Staff Summary Report

SUBJECT: Hold a public meeting for a Development Plan Review for CHURCH ON MILL located at 1300 South Mill Avenue.

COMMENTS: Request for **CHURCH ON MILL – CLASSROOM BUILDING (PL070066)** (First Southern Baptist Church of Tempe, owner; Joel Nice, Bardusen Architects, applicant) for a +/-14,600 s.f. classroom and administration building added to an 13,932 s.f. worship and ministry campus on +/- 3.16 acres, located at 1300 S. Mill Avenue, in the R-2, Multi-family Residential District. The request includes the following:

DPR07139 – Development Plan Review including building elevations, site plan and landscape plan for a one-story classroom and administrative building built in an L-shape on the south side of the lot.

01/18/07
01/08
A3-1
Elevations

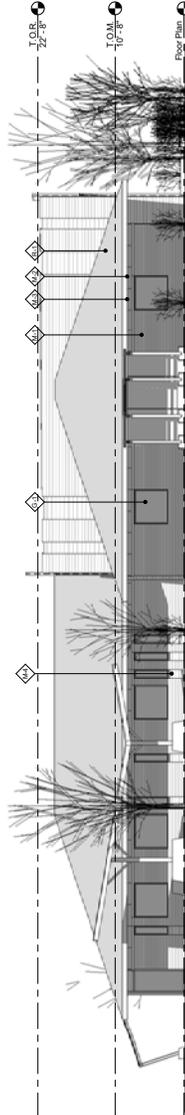
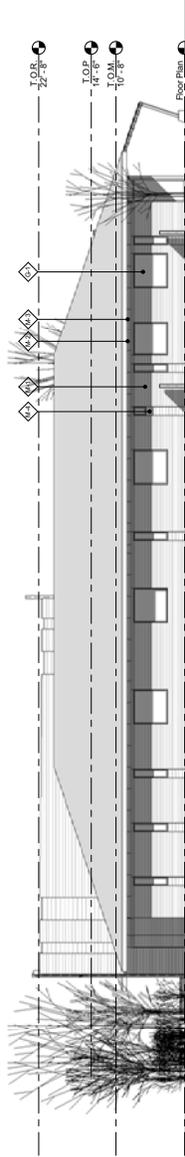
3. Hudson Lane Elevation Design (Break up Roof Line)

Resolution:

- The central parapet element breaks up the large expanse of roof and adds a dramatic modern element with a cross that indicates the building is a church use.
- The mechanical units are located on the roof and therefore screen walls at ground level are not required
- Cantilevered roof extension on the west side creates a porch feel

L1.0
CONCEPTUAL PLANTING PLAN
Sheet No.

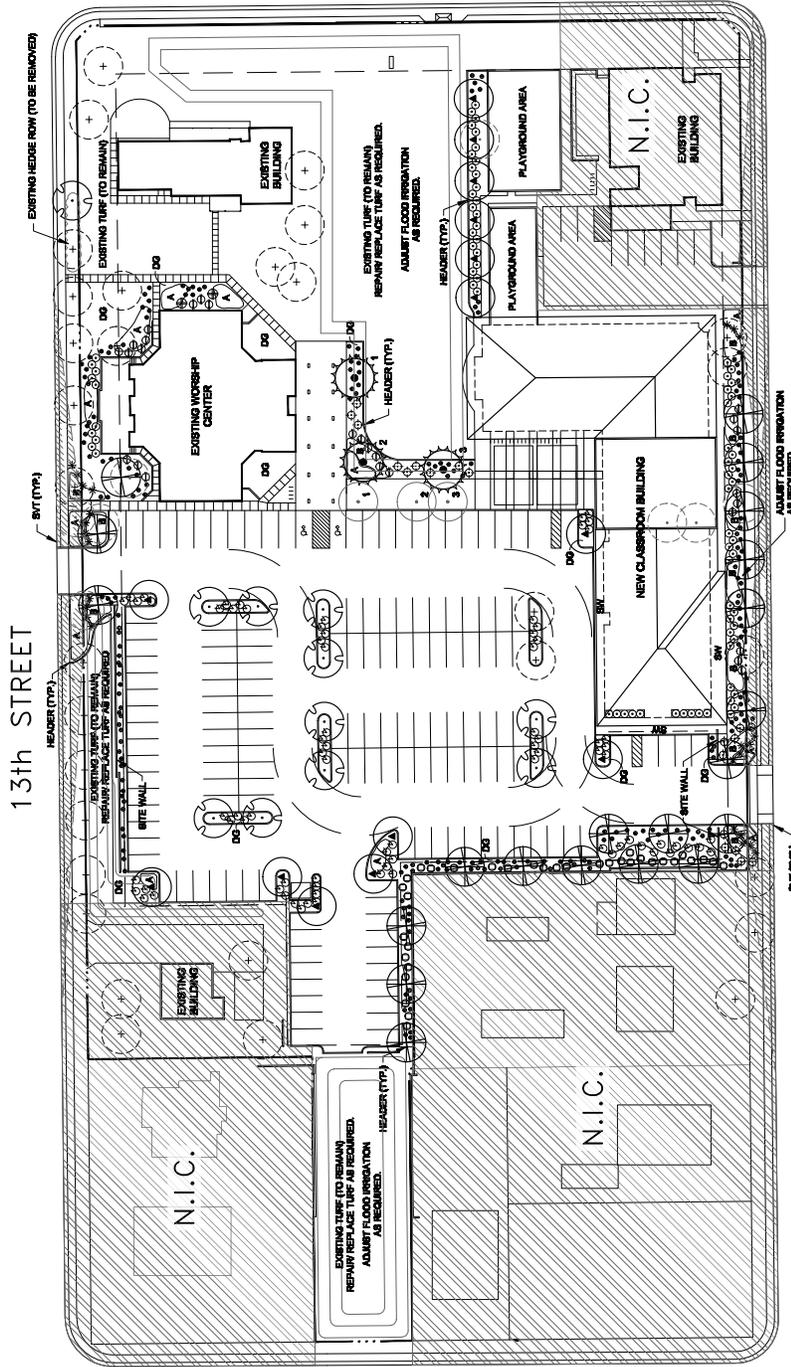
1. Saving Existing Large Trees

Resolution: We are now saving all existing trees except one dying tree and one tree close to the sidewalk on Hudson. Two additional trees to be removed are in the proposed building footprint.
